Enhanced Child Restraint Systems Legislation issues UN R129 and UN R145

May 2022

Requirements on Lower Tether Anchorages & Attachments GRSP-71-19

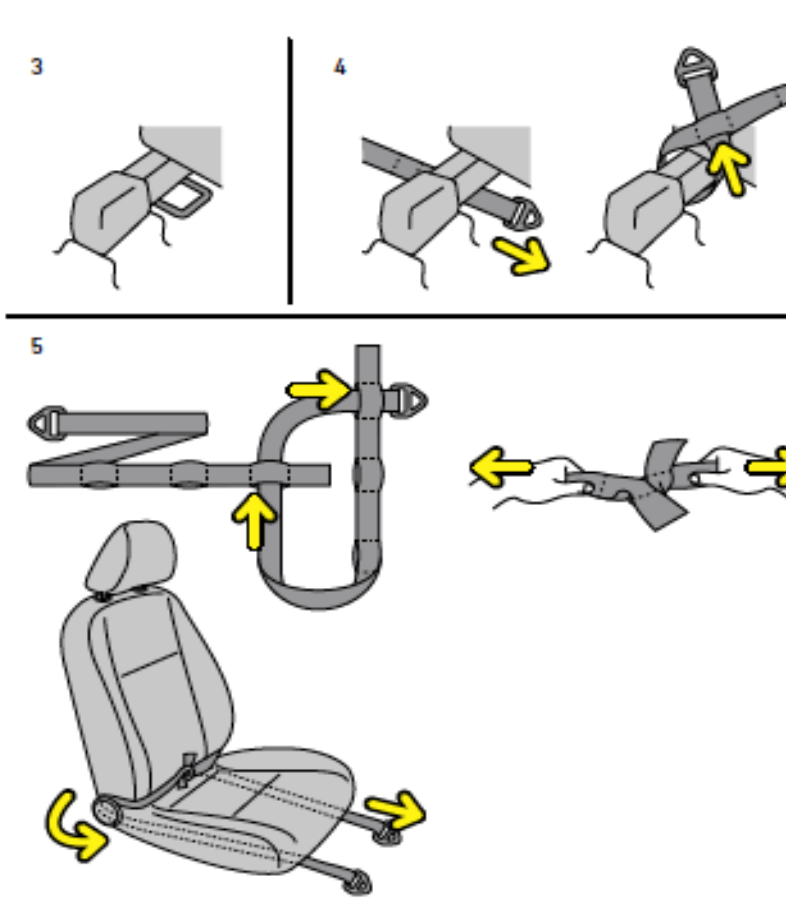
- Can an ECRS be approved under UN R129.03 including the lower strap anchorages ?
n.b. Several ECRSs have already been approved to UN R129.03. Different interpretations exist.

- What are the strength requirements which apply for them ?
 1. same requirements that in general apply for straps and retractors ?
 2. no specific requirements – responsibility of the ECRS manufacturer ?n.b. both interpretations were received

- What kind of anchorages are allowed and who decides ?
(ECRS manufacturer versus vehicle manufacturer)
